DEVELOPMENT APPLICATION ASSESSMENT REPORT

Application Number:	DA2025/0351
----------------------------	-------------

Responsible Officer:	Julie Edwards
Land to be developed (Address):	Lot 2 DP 1109097, 28 A Cliff Street MANLY NSW 2095
Proposed Development:	Alterations and additions to a semi-detached dwelling
Zoning:	Manly LEP2013 - Land zoned R1 General Residential
Development Permissible:	Yes
Existing Use Rights:	Yes
Consent Authority:	Northern Beaches Council
Delegation Level:	DDP
Land and Environment Court Action:	No
Applicant:	Timothy John Ramson

Image 1: Building height non-compliance shaded in red.

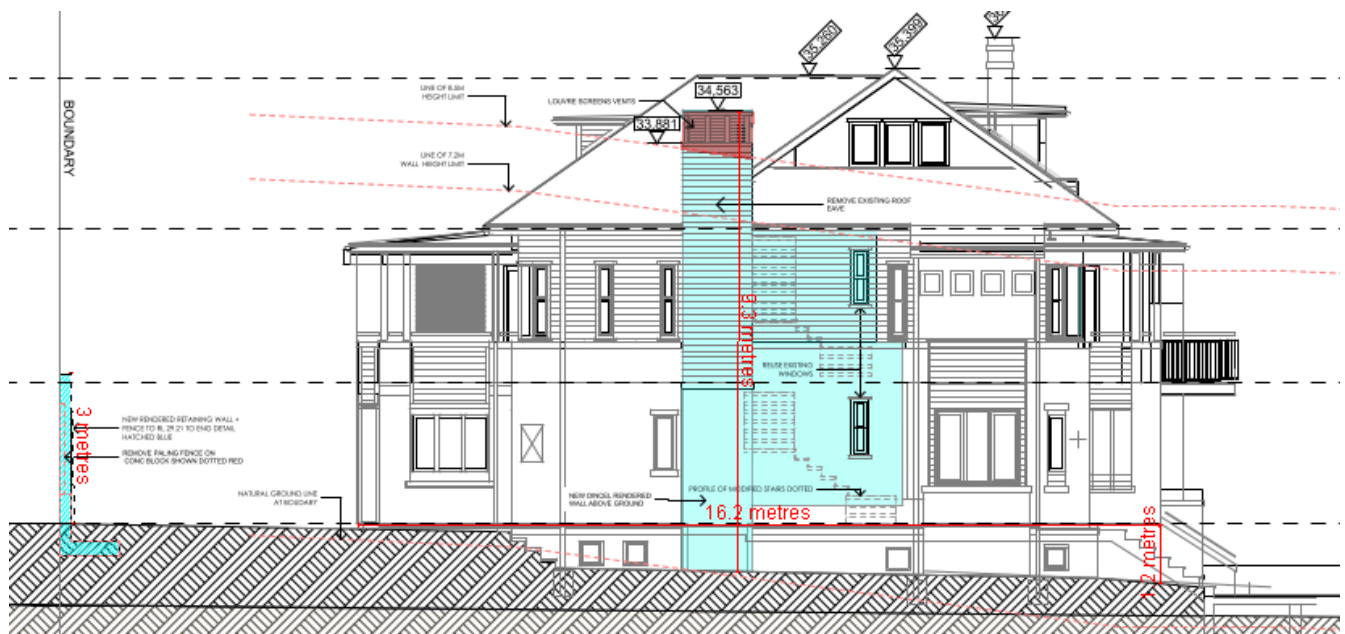
Proposed: 9.3m

Percentage of variation: 9.4%

Image 2:

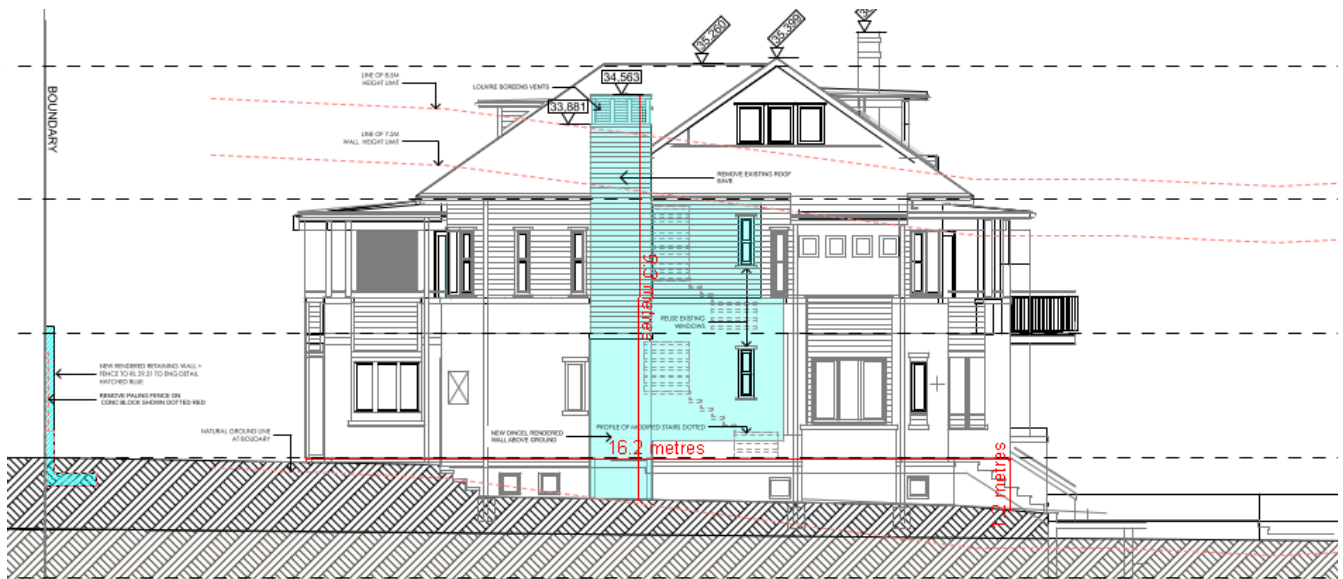
Clause 4.1.2.1 of the Manly Development Control Plan 2013 (MDCP) stipulates that the maximum wall height permitted on the western elevation is 6.9m. The application proposes a wall height of 9.3m for the lift shaft and 6.9m for the wall height. This is consistent with the existing wall height along the eastern elevation.

The application also includes a rear fence/retaining wall along the south-eastern rear boundary. The fence/retaining wall has a height of 3.1m. This is considered excessive and is not supported. The existing rear boundary fence has an RL of 28.3 and a height of 2.11m. A condition will be included in the consent requiring the fence/retaining wall to have a maximum height of 2.1m or RL 28.3 to match the existing fence height. While it is noted that the proposed retaining wall/fence height is to match the rear fence/retaining wall at no 28 Cliff Street, no approval can be found for the wall.
